SECTION 009113 – ADDENDUM TWO

Project Name: 22045 Amite County Elementary School Parking
Lot & Site Development

- A. Owner: Amite County School District, 533 Maggie Street, Liberty, MS 39645A
- B. Architect: Bailey Architecture Education, P.A., 201 Park Court, Suite B, Ridgeland, MS 39157
- C. Architect Project Number: 22045
- D. Date of Addendum Two: 23 February 2023

SET/SHT
C-202
 GRADING & DRAINAGE
 PLAN - NORTH LOT

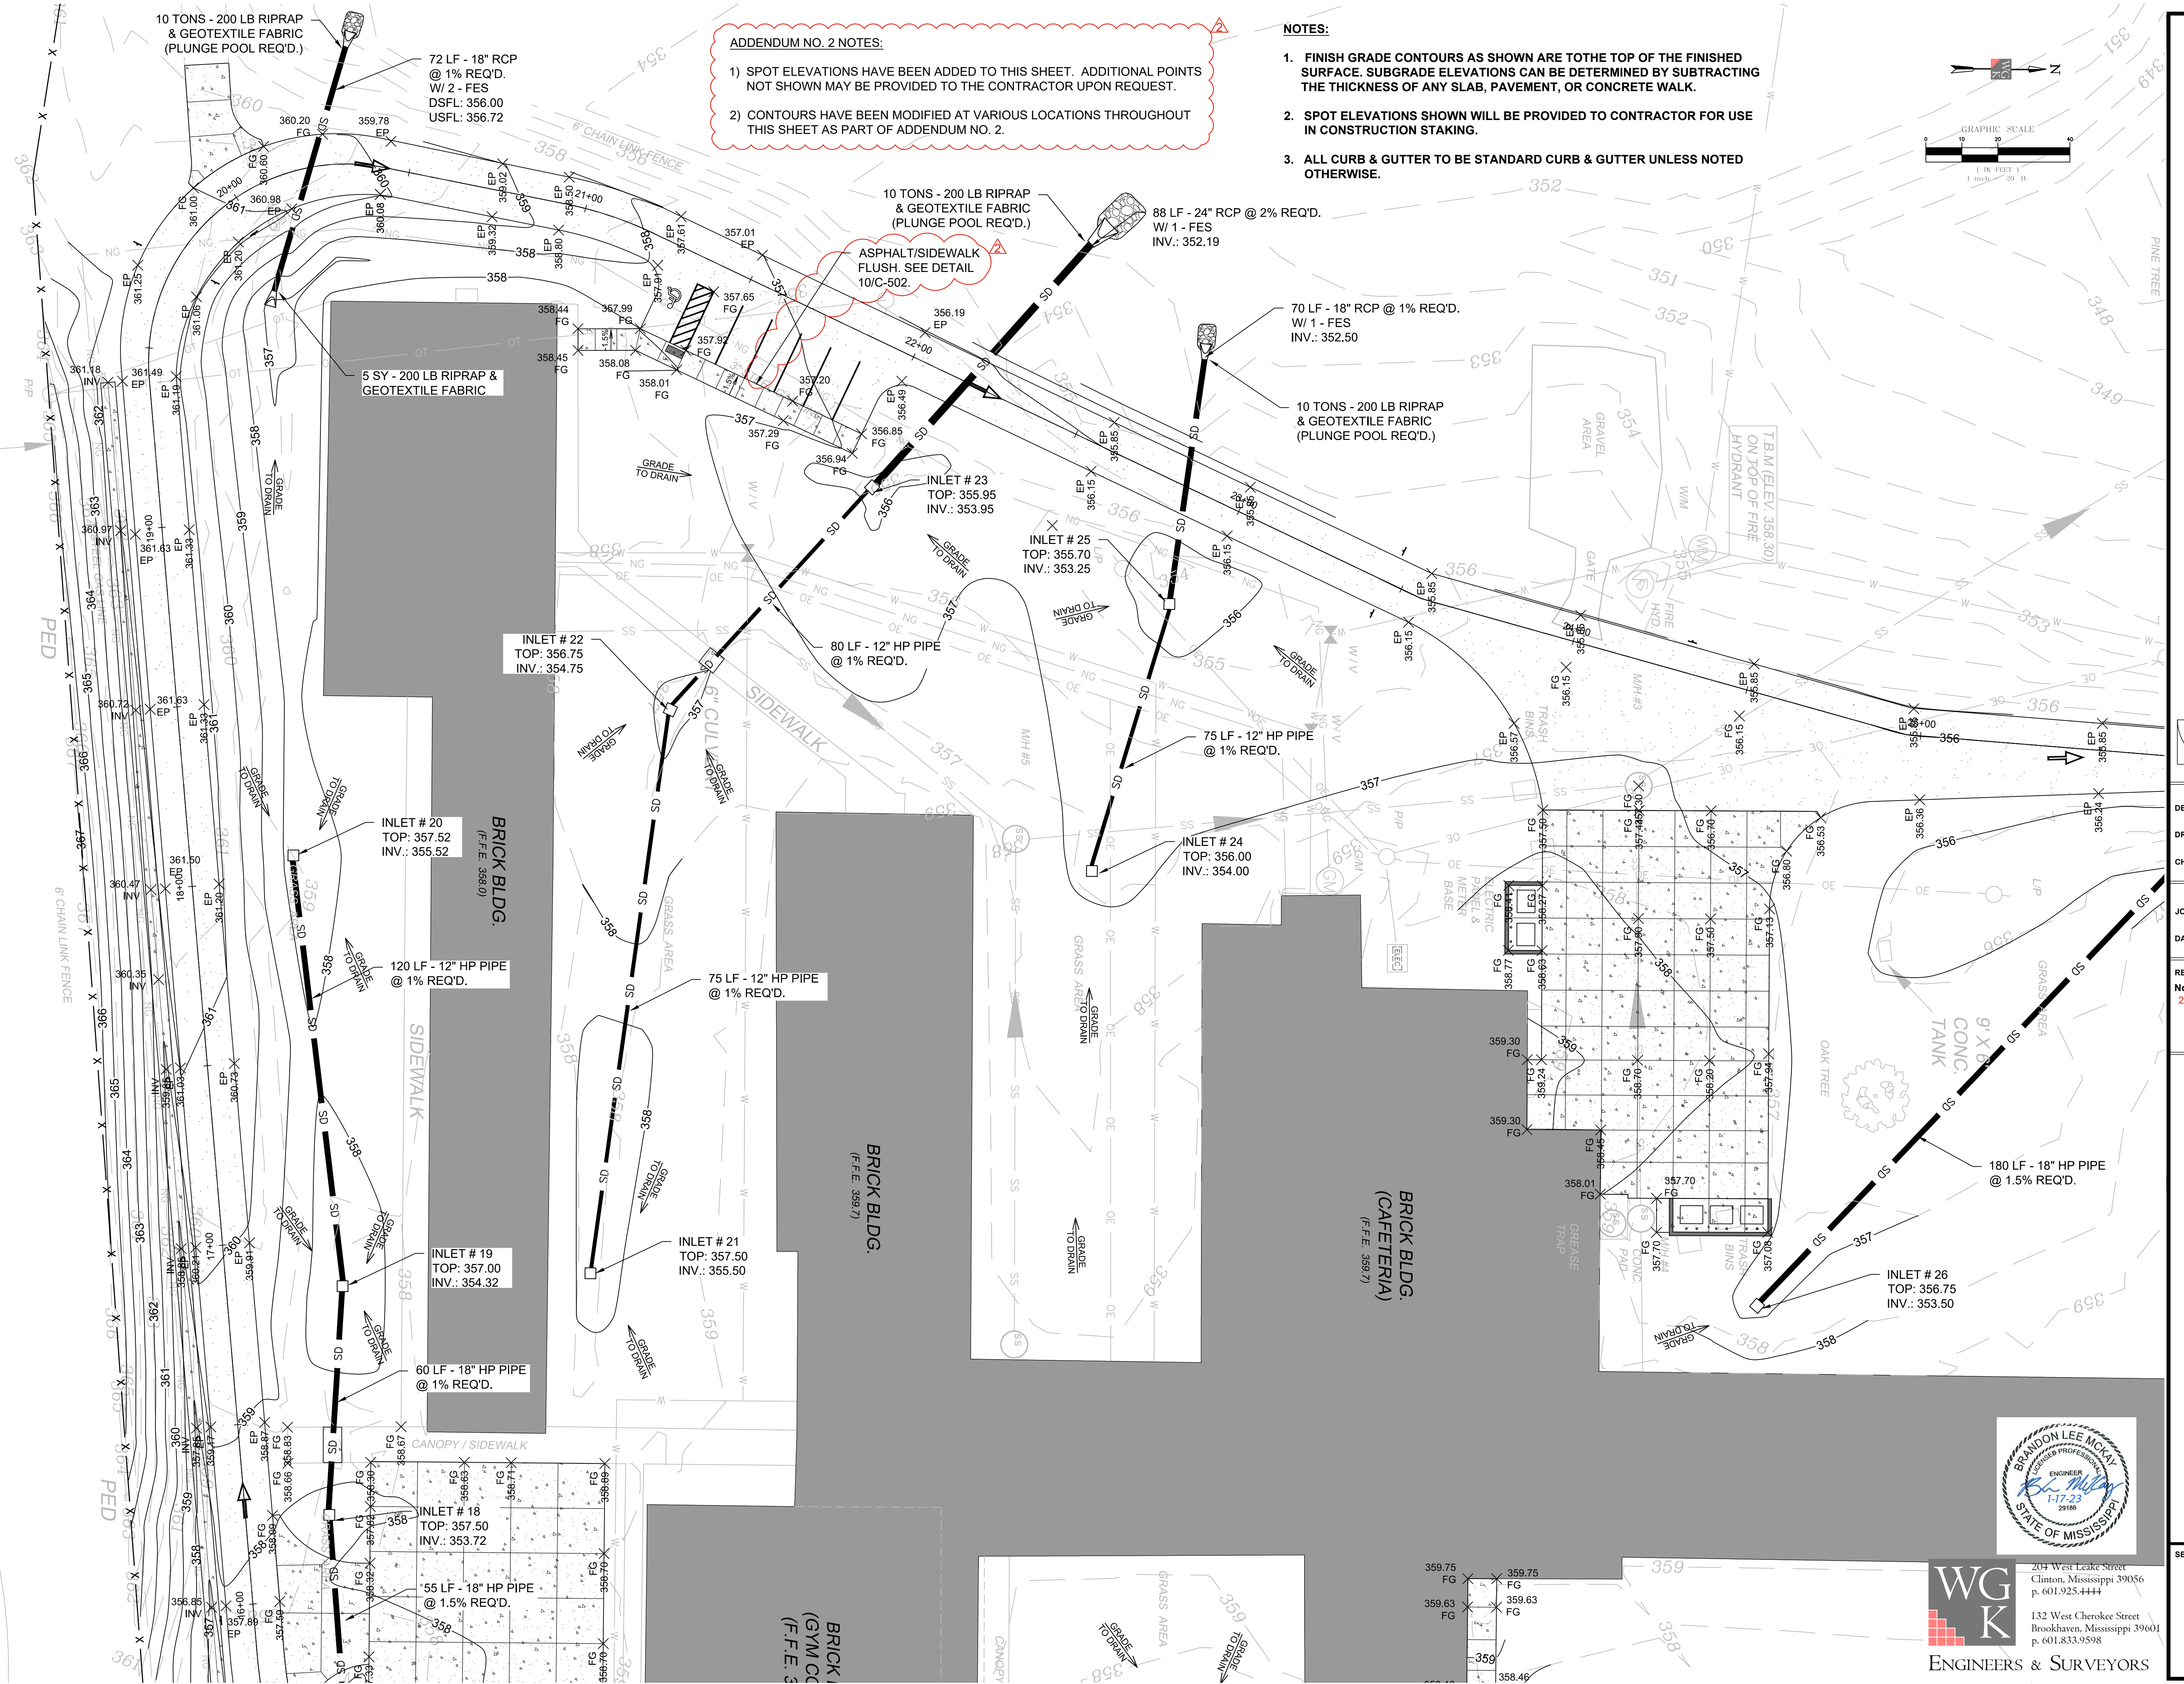
KK. QUESTION: The 24" RCP on Sheet C-202 (48LF) is not shown all the way to outlet. On Sheet C-201 is scales to 96LF.

ANSWER: The scaled dimension of 96 LF is correct instead of the 48 LF that is shown in the annotation.

ADDENDUM NO. 2 NOTES:
1) SPOT ELEVATIONS HAVE BEEN ADDED TO THIS SHEET. ADDITIONAL POINTS NOT SHOWN MAY BE PROVIDED TO THE CONTRACTOR UPON REQUEST.
2) CONTOURS HAVE BEEN MODIFIED AT VARIOUS LOCATIONS THROUGHOUT THIS SHEET AS PART OF ADDENDUM NO. 2.

C-301
 GEOMETRIC LAYOUT - OVERVIEW

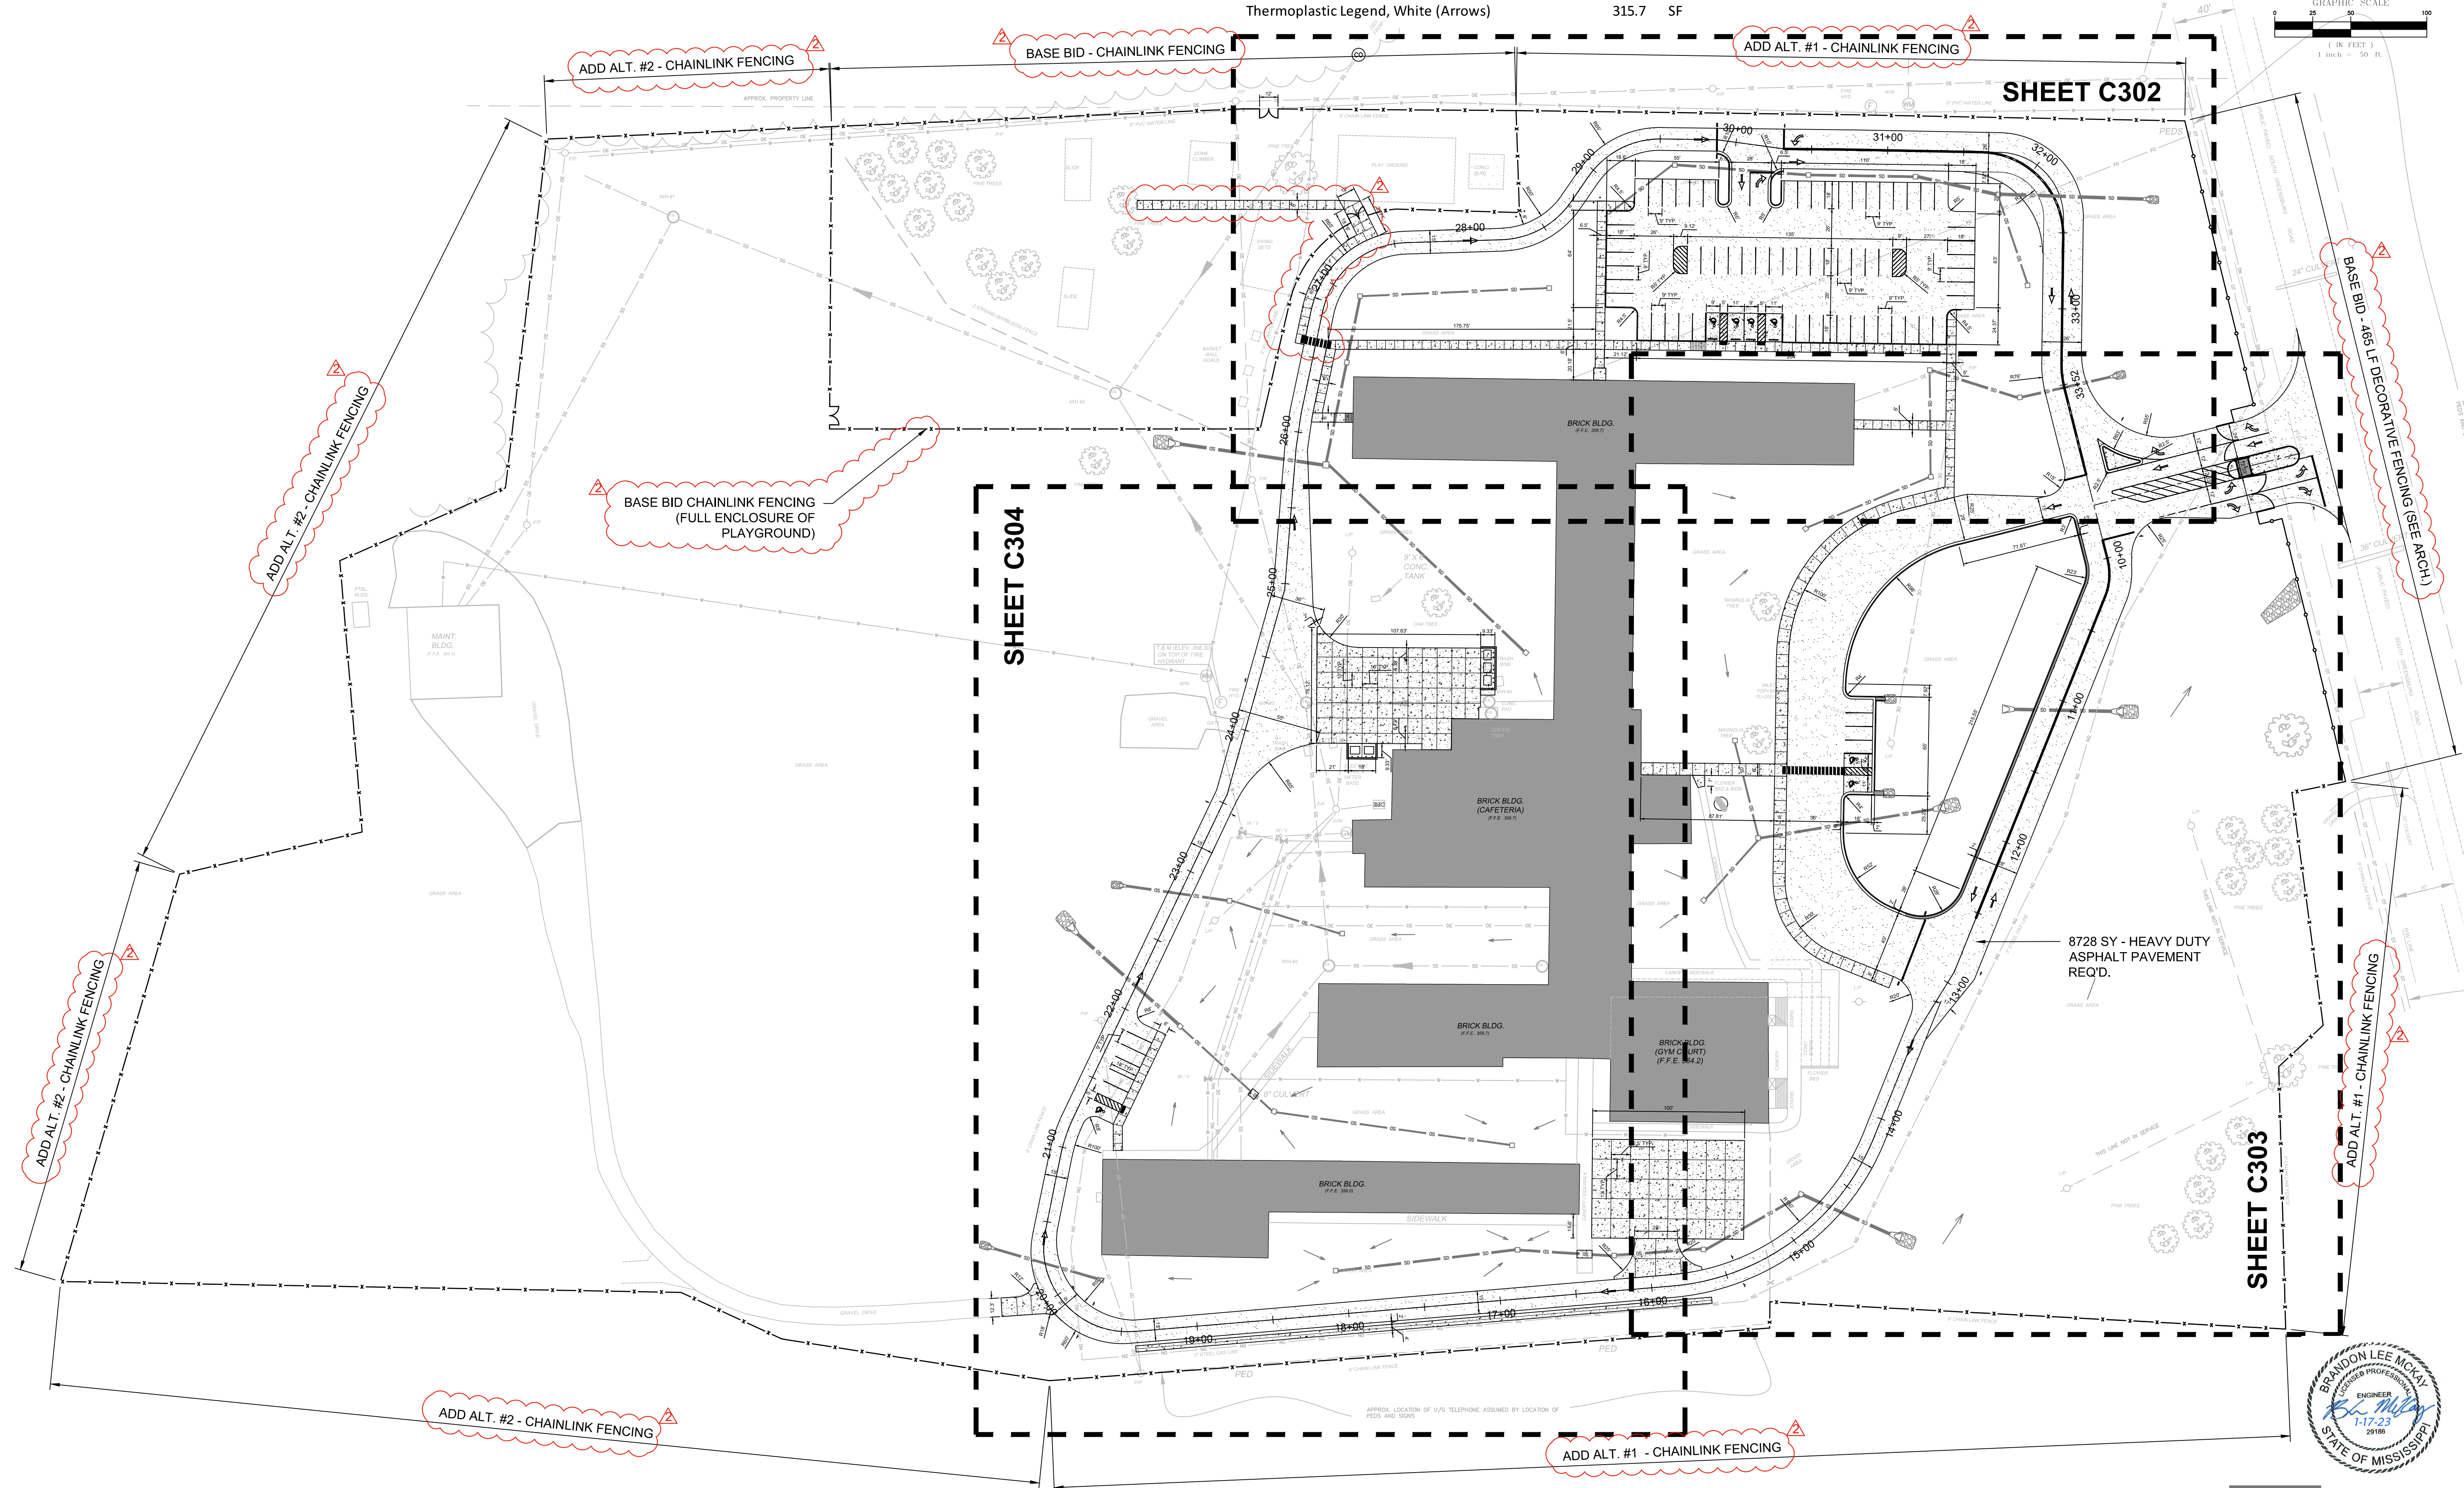
- L. QUESTION: Sheet C-301 Geometric Layout- Overview. The Right Bottom Corner it appears the fencing comes to a stop and is open in that corner, is this correct? Or should the fencing continue into the corner and go back to continue the other fence line?

- F. Sheet C-204 – GRADING & DRAINAGE PLAN – WEST DRIVE. Added notes, spot elevations, and revised contours throughout. See attached.
- G. Sheet C-301 – GEOMETIC LAYOUT -- OVERVIEW. Separated fencing into alternates and added sidewalk to new playground area. See attached.
- H. Sheet C-302 – GEOMETIC LAYOUT – NORTH LOT. Added notes, stair detail, fence gate, sidewalk to new playground area. See attached.
- I. Sheet C-303 – GEOMETRIC LAYOUT – EAST LOT. Added note regarding concrete at guardhouse. See attached.
- J. Sheet C-304 – GEOMETIC LAYOUT – WEST DRIVE. Added concrete ditch along South end of site. See attached.
- K. Sheet C-502 – CONSTRUCTION DETAILS. Modified asphalt details per Geotech report. See attached.
- L. Sheet C-601 – EROSION CONTROL PLAN. Added erosion blanket notes and removed references to solid sodding. See attached.

ANSWER: See revised fencing layout published in addendum. It clarifies this question. There is to be no gap in fencing.

BASE BID	= 1265 LF
ADD ALT. #1	= 1675 LF
ADD ALT. #2	= 1780 LF
